**49 Shearwater Lane (APN 052-291-12)
Residential Development**

Biotic Report

Updated June 29, 2021

**RE: Addendum to Biotic Report and Conceptual Restoration Plan, 49 Shearwater Lane,
Pajaro Dunes South (APN 052-29-108)**

Figure 2. Distribution of vegetation types and special status plant species

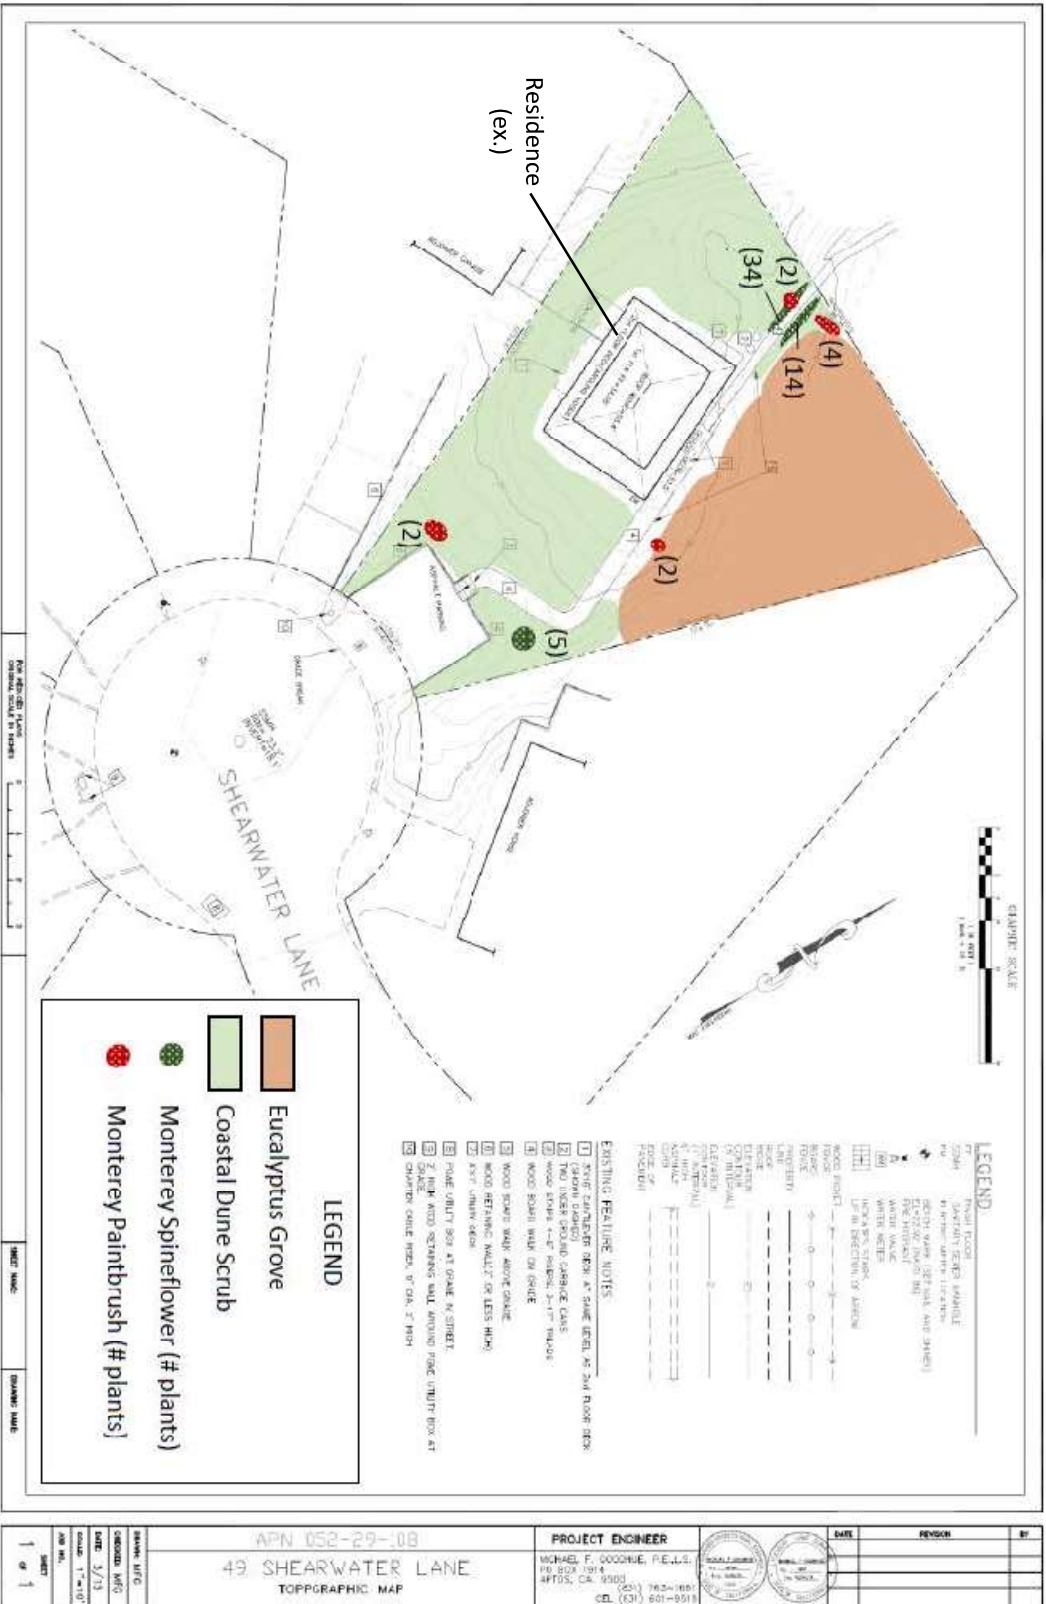
The Biotic Report identifies two vegetation communities on the property: dune scrub and non-native eucalyptus grove. The majority of the coastal dune scrub on the property is dominated by non-native invasive plant species. The north and northwest sides of the property support a dense mat comprised of invasive European dune grass (*Ammophila arenaria*), ice plant (*Carpobrotus edulis*), and ripgut brome (*Bromus diandrus*). East of the existing residence, the parcel slopes downward. The northeastern corner of the triangular shaped property is dominated by an overstory of very large eucalyptus trees growing on and at the bottom of the slope, with large branches overhanging in a westerly direction toward the house. In the southern portion of the property, and along the east side of the existing residence at the top of the slope, iceplant is interspersed with a mosaic of native species including two special-status species: Federal Threatened Monterey spineflower (*Chorizanthe pungens* var. *pungens*) and Monterey paintbrush (*Castilleja latifolia*), a locally unique plant species. Figure 2 of the Biotic Report shows the location of these communities and special-status species identified on the parcel.

Figure 11. Conceptual dune restoration, on-site area and potential off-site areas.

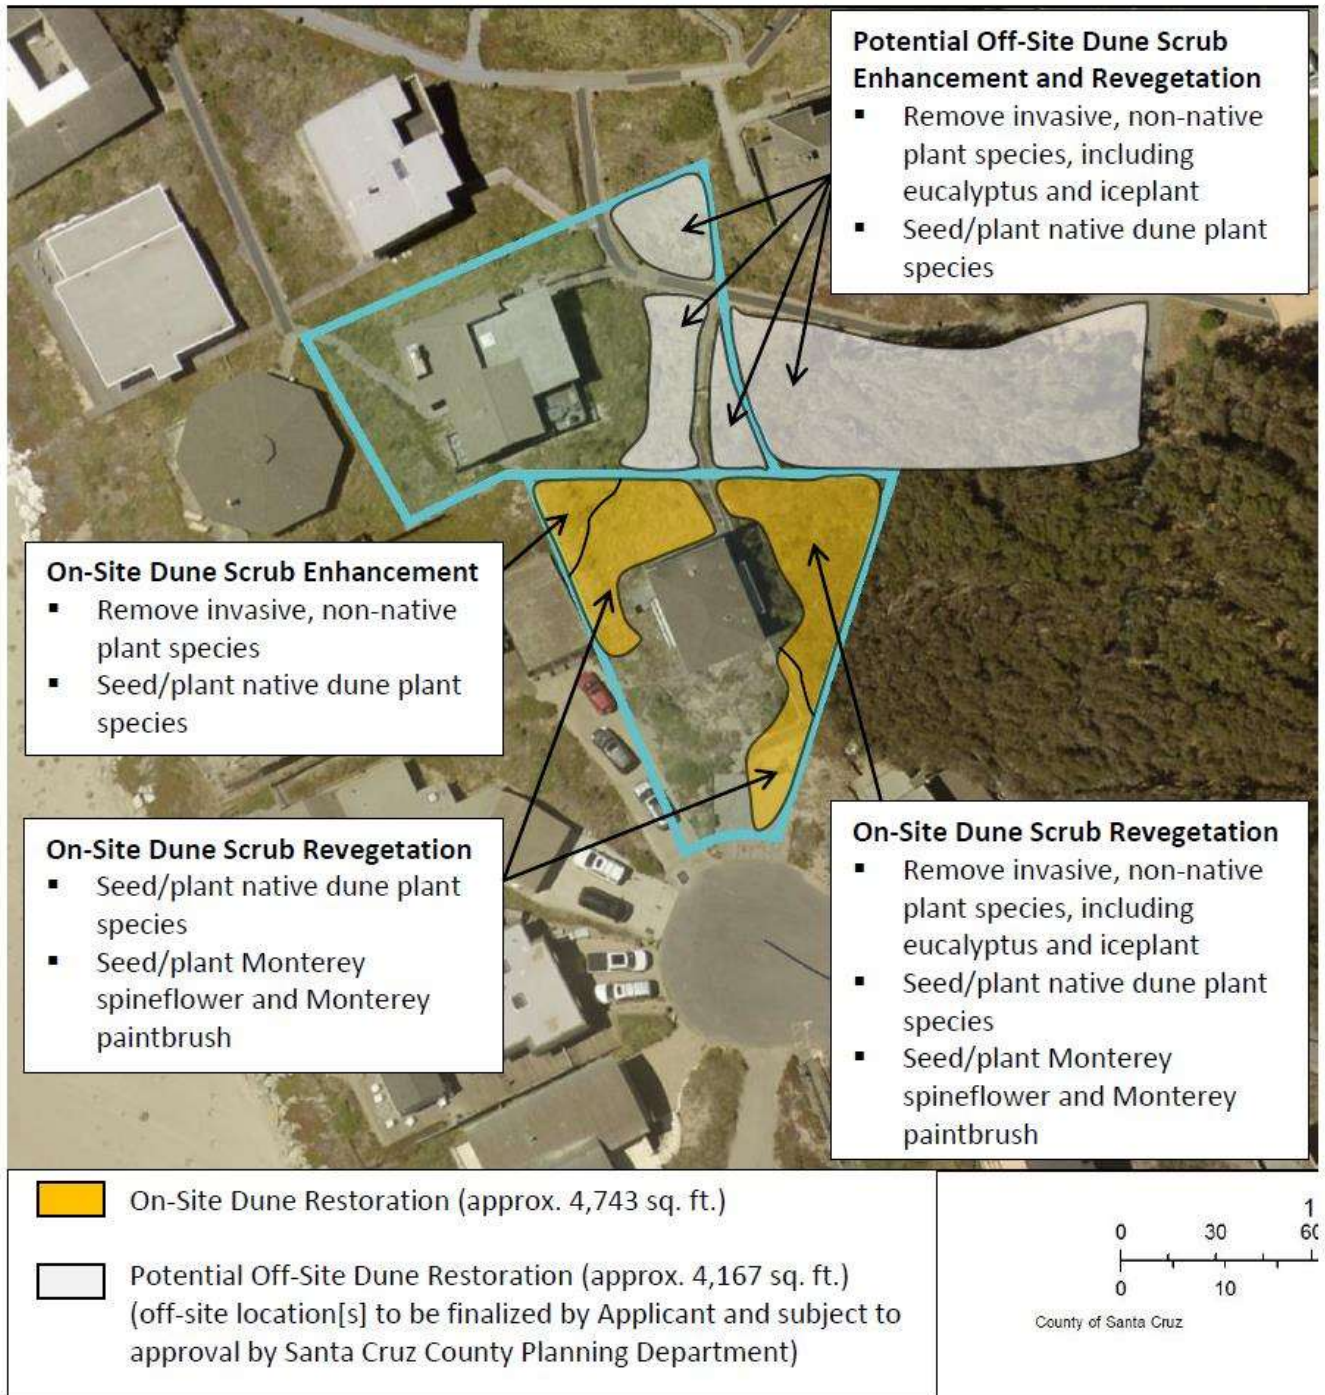
The Biotic Resources Group has prepared this addendum to the Biotic Report, (Biotic Resources Group, June 29, 2021) in response to comments from the County (email dated March 2, 2022, Matt Johnston). The addendum addresses the issue of proposed dune scrub restoration areas that could be shaded by decks and provides an updated conceptual dune scrub restoration plan.

Pursuant to SCCC 13.20, mature trees in the Coastal Zone should be retained when possible. The eucalyptus grove in the northeast corner of the parcel is considered less suitable for dune restoration than the off-site neighboring locations proposed for restoration in the conceptual restoration plan on Figure 11 of the Biotic Report.

FUSE Architects + Builders conducted a shade analysis of the proposed residence. The analysis, based on the approximate sun shadow at noon on the summer solstice, identified that 764.75 square feet of potential proposed dune restoration area would be located in these shadows. This shade analysis is depicted on Figure A-1, attached. As per the County's concerns that shaded areas would be unsuitable for dune scrub restoration, these shaded areas will be excluded from areas considered for dune restoration. However, any existing dune scrub vegetation that occurs in these shaded areas will be retained as is.

As per the Site Plan, as depicted on Figure A-1, areas temporarily impacted by construction will be restored. This area encompasses 2,805 square feet. This is an update to the area identified for on-site restoration in the Biotic Report, dated June 29, 2001.

To meet the County's requirement for mitigation, 5,101 square feet of off-site dune restoration will occur. This is an update to the area identified for off-site restoration in the Biotic Report, dated June 29, 2001. This updated information is portrayed on Figure A-2.
